ANADROMOUS WATERS CATALOG/ATLAS
CORRECTION FORM

MAP: SEWARD B-4

WATERWAY NUMBER: 226-20-16030
226-20-16030-0010

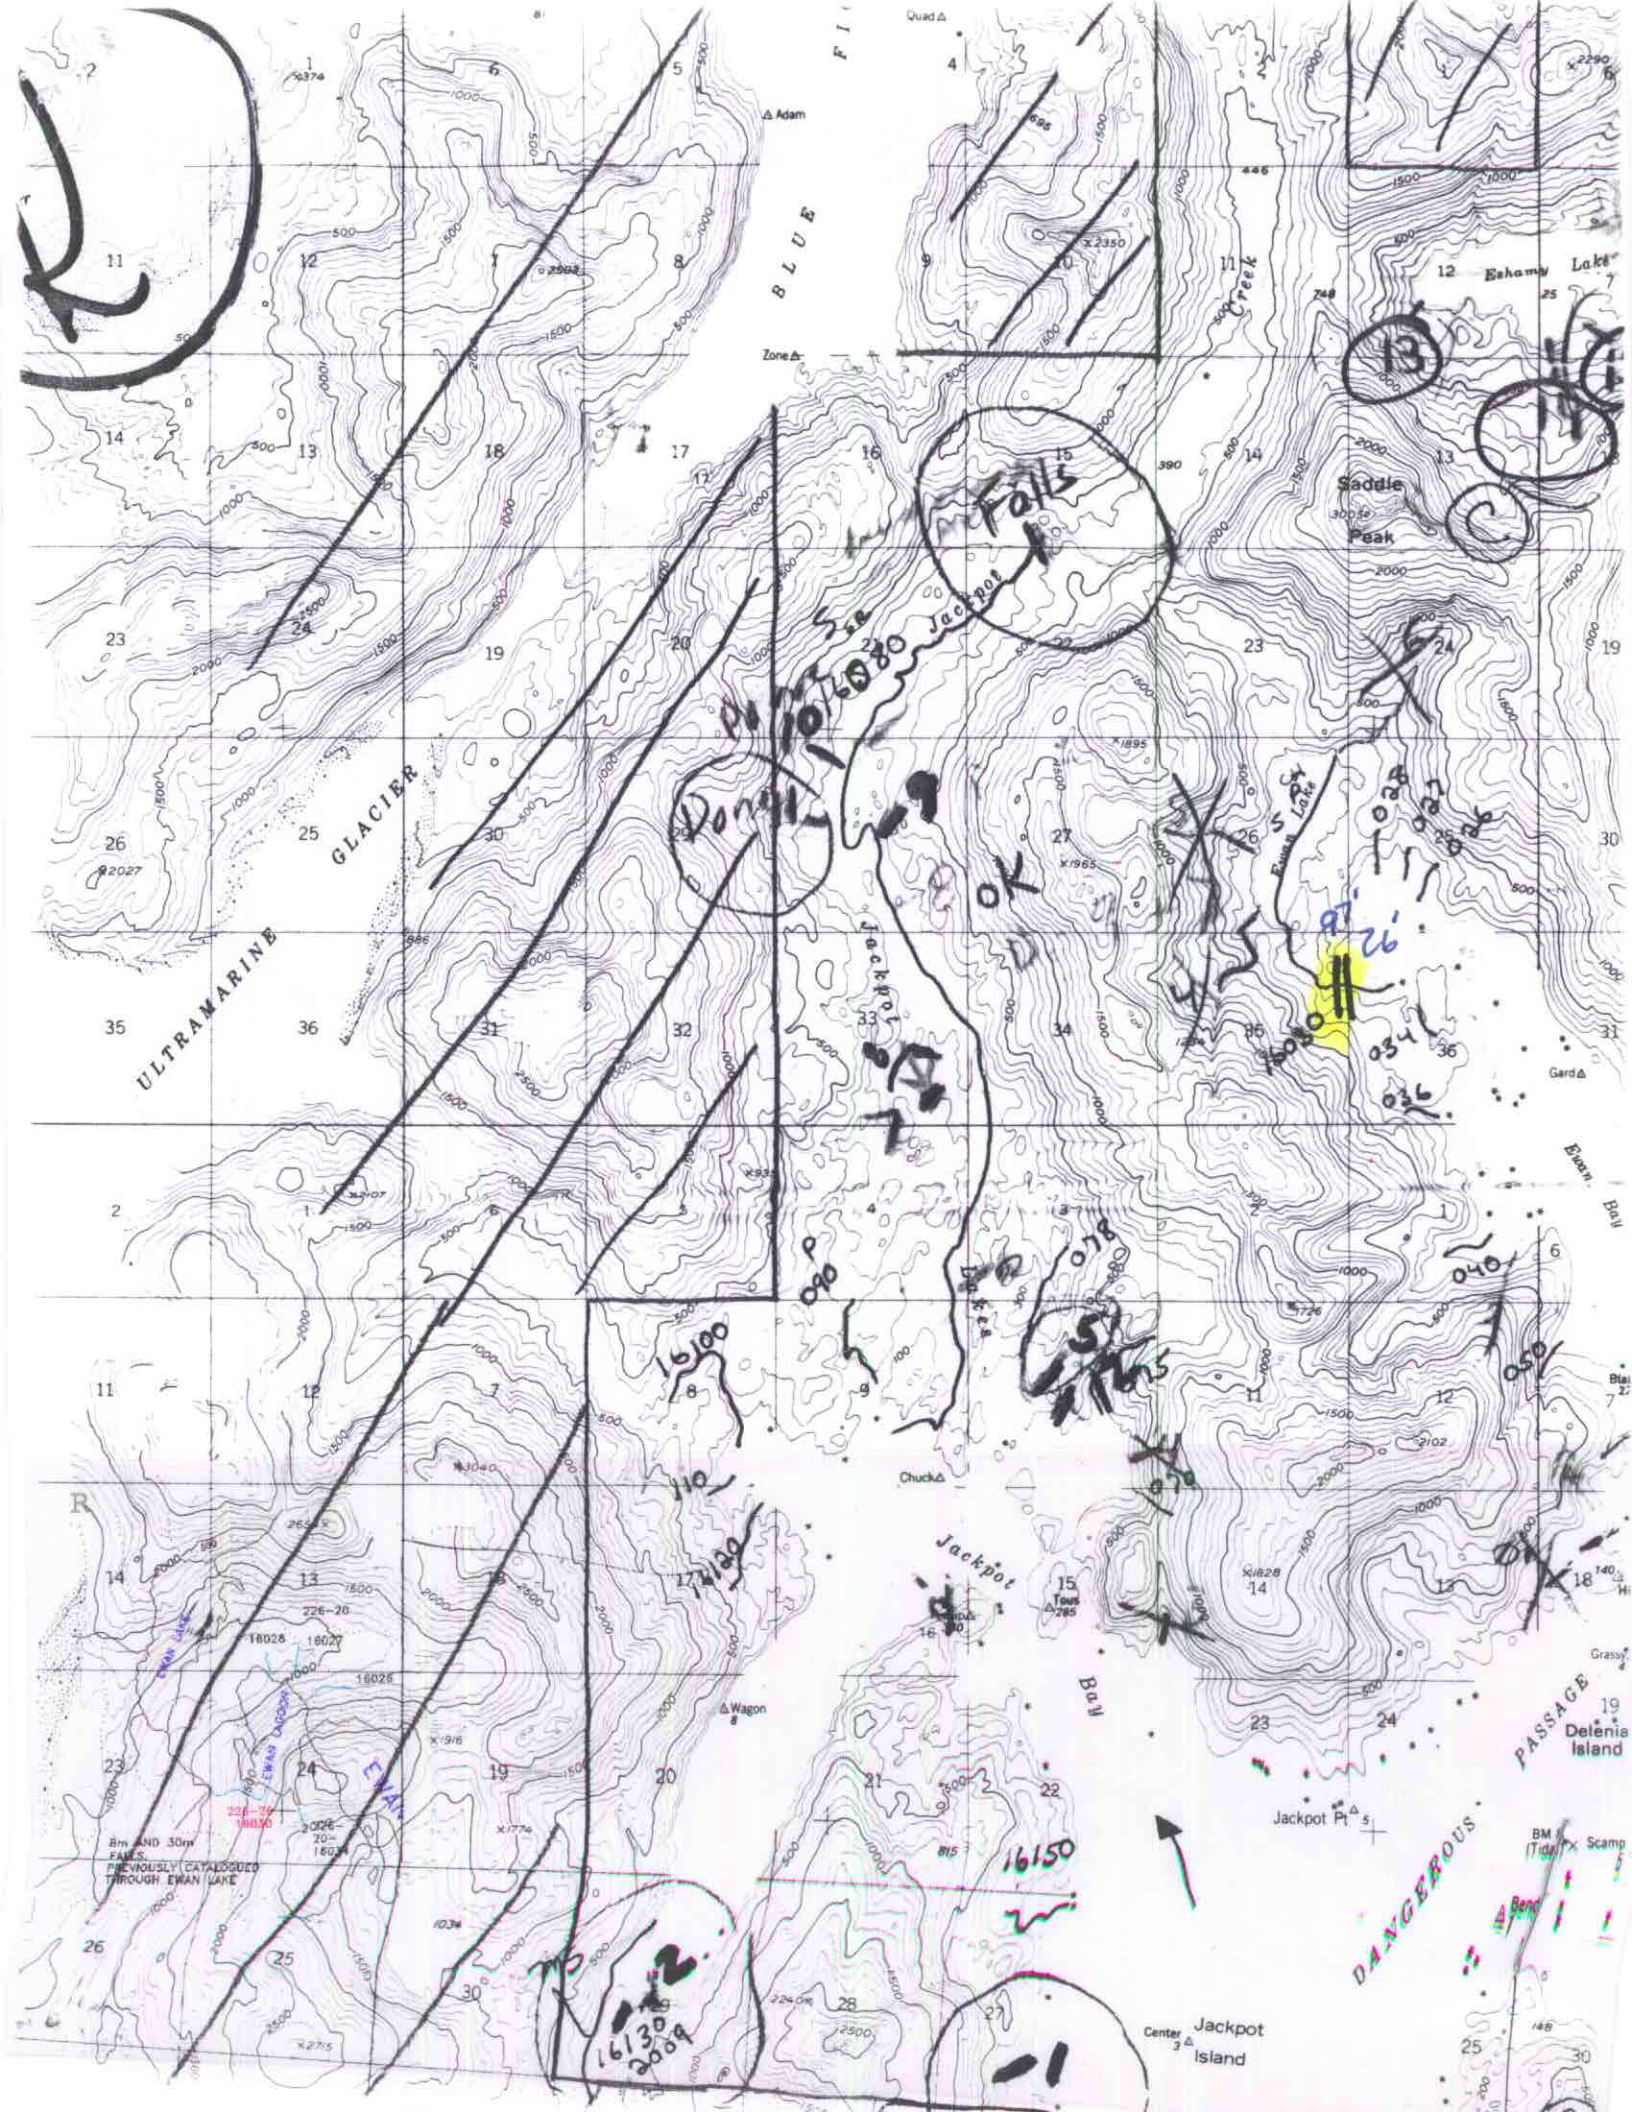
DESCRIBE CHANGE(S): DELETE UPPER PORTION OF STREAM # LAKE: 226-20-16030 & 0010 DUE TO IMPASSABLE BARRIER. A 8m FALLS FOLLOWED BY A 30m WATERFALL EXISTS AT THE NOTED LOCATION. ADD BARRIER NOTATION TO FALLS 26 FT TO ATLAS MAP. USGS BASE MAP IS ALSO OUTDATED GET NEWEST VERSION. THIS STREAM IS IN WRONG LOCATION ON OURS: CHECK ATTACHED MAP & MYLAR OVERLAY.
